KD8 (-B) Modular Door Station(Main Module)

Release Note (2025-11-07)

Device Model	Firmware Version
DS-KD8003-IME1(B), DS-KD8003-IME1(B)/Surface DS-KD8003-IME1(B)/Flush, DS-KD8003-IME1(B)/S DS-KD8003-IME1(B)/NS, DS-KD8003Y-IME2 DS-KD8003Y-IME2/S, DS-KD8003Y-IME2/NS DS-KIS602(B), DS-KIS702Y	V3.7.1_build250929

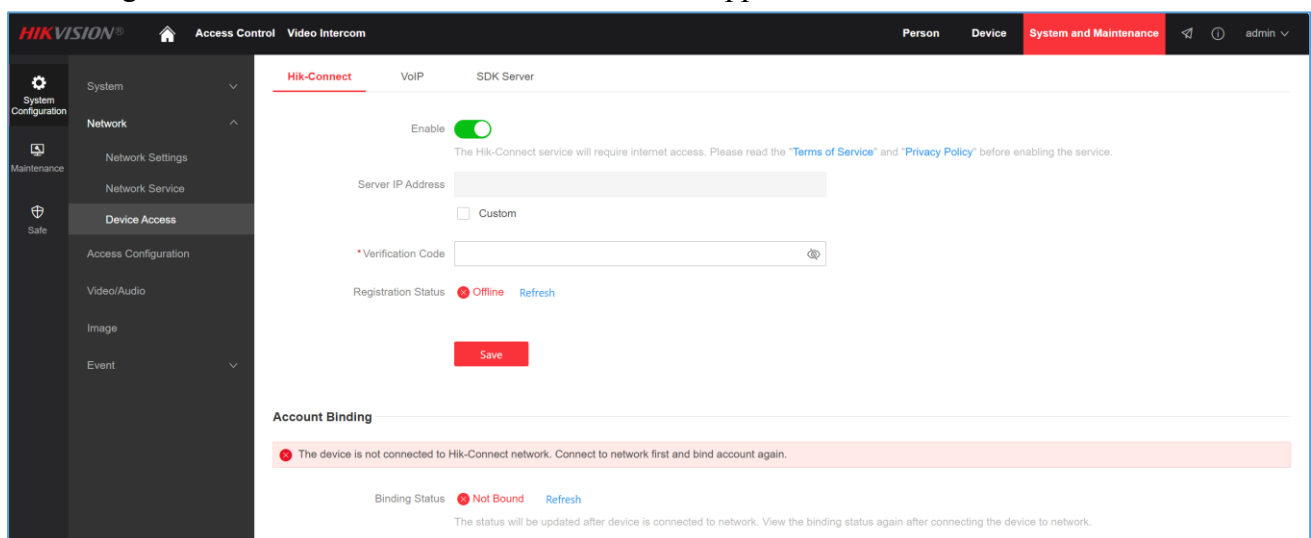
- Update to new webpage UI

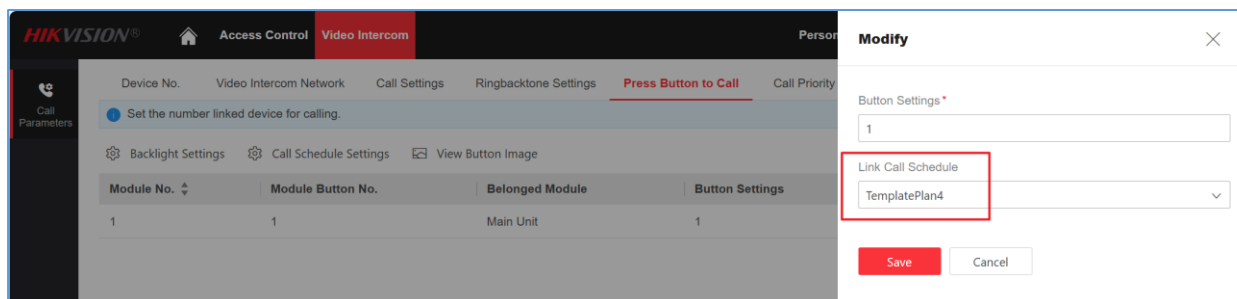
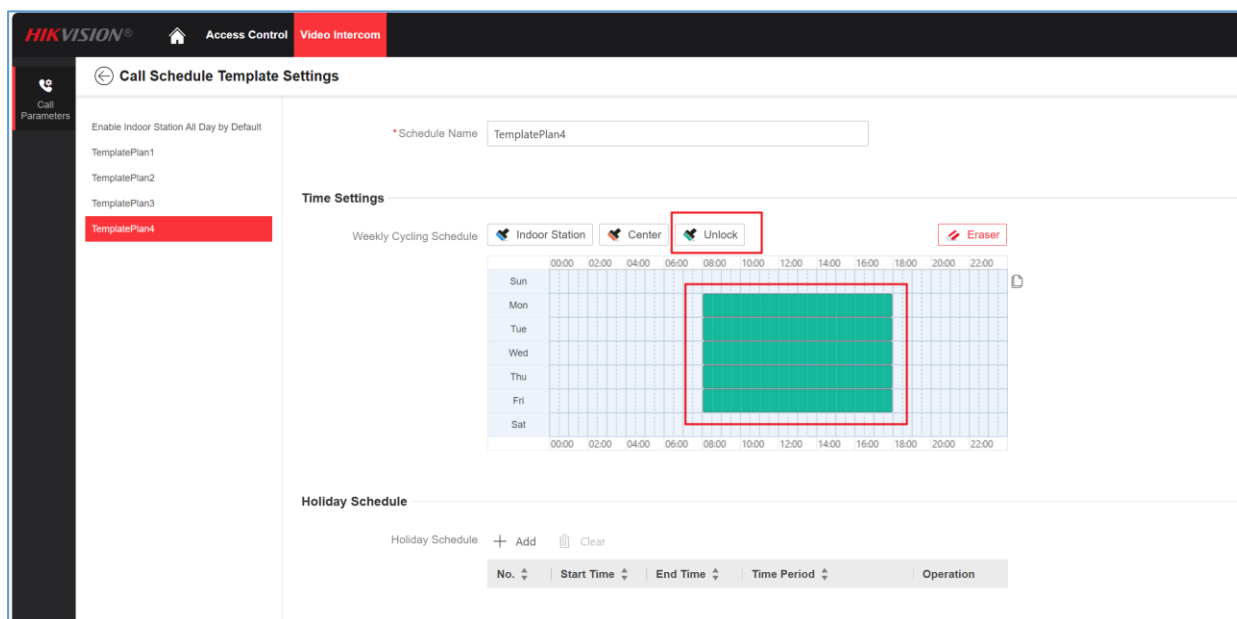
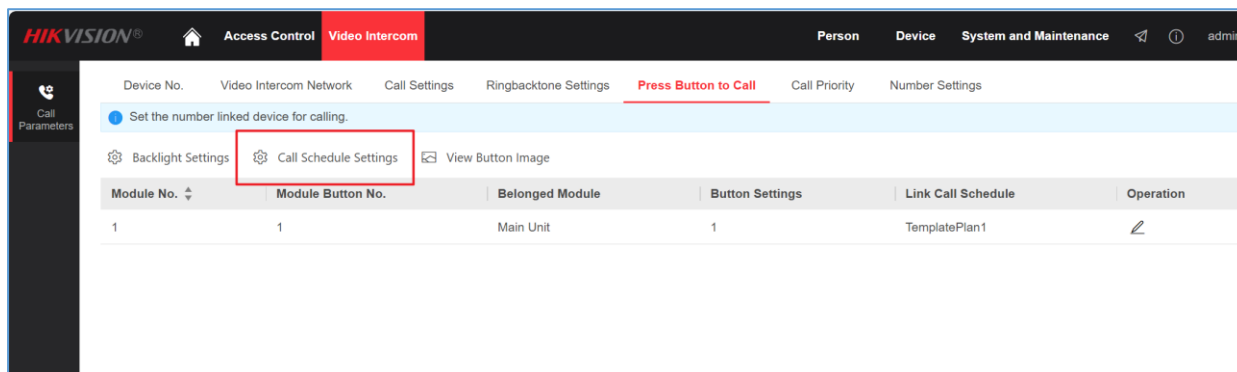
10. Support trade button (automatically unlock door after receive call) function.

For example, if you set same schedule as below pictures, the door will unlock automatically after receive the call from button1 between Monday to Friday 8:00-18:00

- 1) Each button (of main module and nametag DS-KD-KK or DS-KD-K12 module) can only be linked to one template only.
- 2) Only lock1 will be open automatically, lock2 doesn't support trade button function.

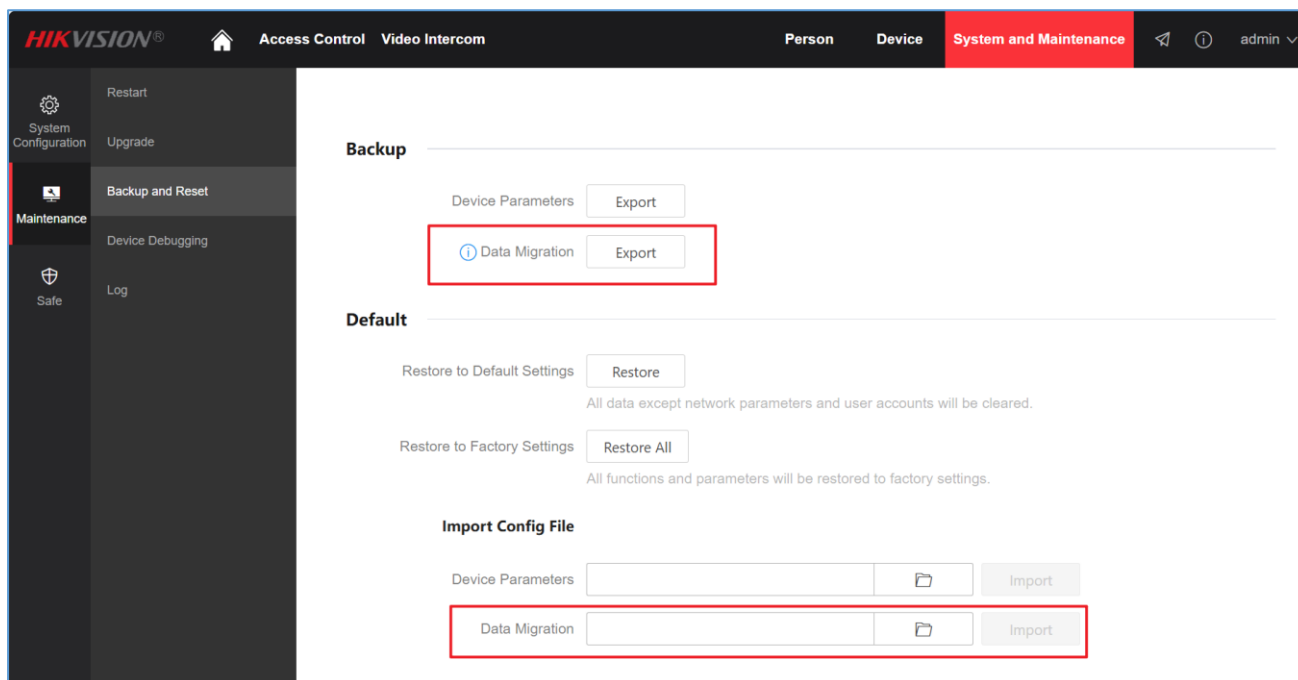
4. Support 2 sip lines and input special characters in SIP number settings, including *.#+==-/()\$%[]{} _

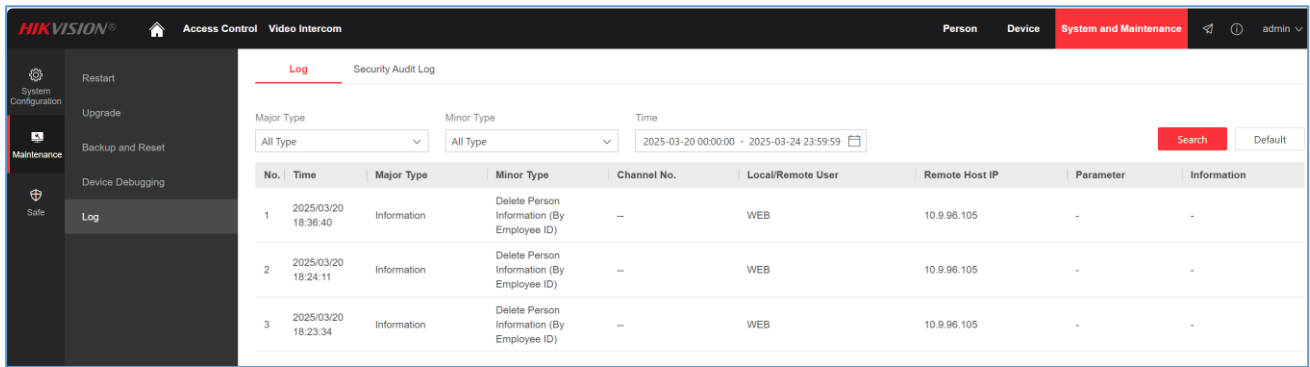
6. When changing the device mode between door station and outer door station, all personnel **data will be deleted**, please take care for the data loss, and add the prompt as below picture.

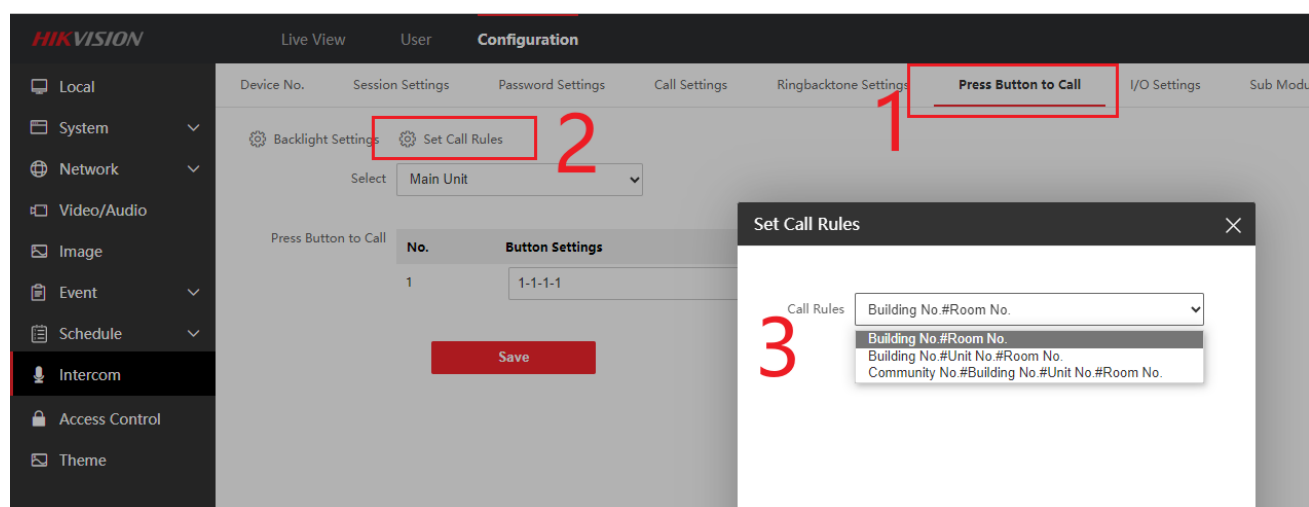
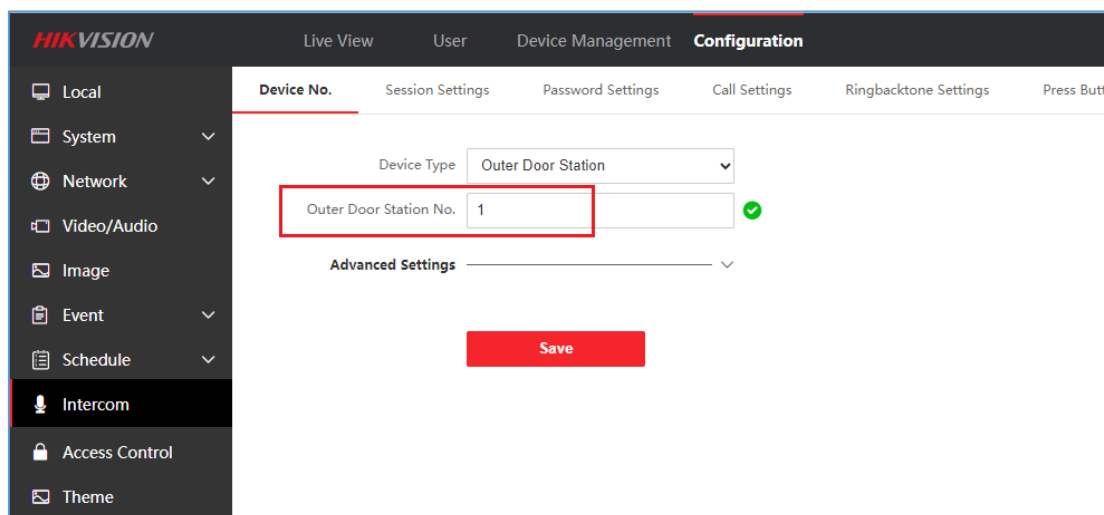
2. Add calling mode for outer door station. It supports 3 modes to call indoor station, and there's no need to input full 4 digits room number. For example 1#1 is calling 1-1-1-1 by default.

- 1) Building No.# Room No.
- 2) Building No.# Unit No.# Room No.
- 3) Community No.# Building No.# Unit No.

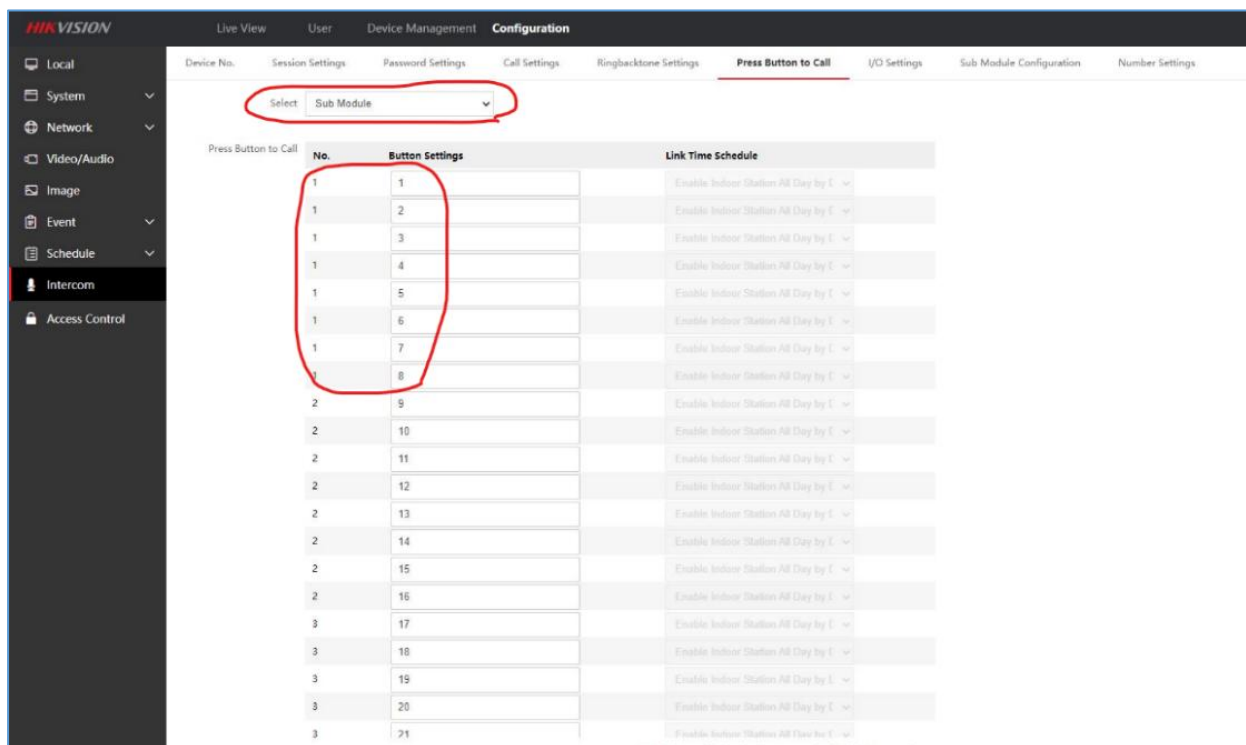
1. Add sub module **backlight** control: 4 modes (close, open, auto and custom), support DS-KD-KK, DS-KD-KP, DS-KD-INFO modules
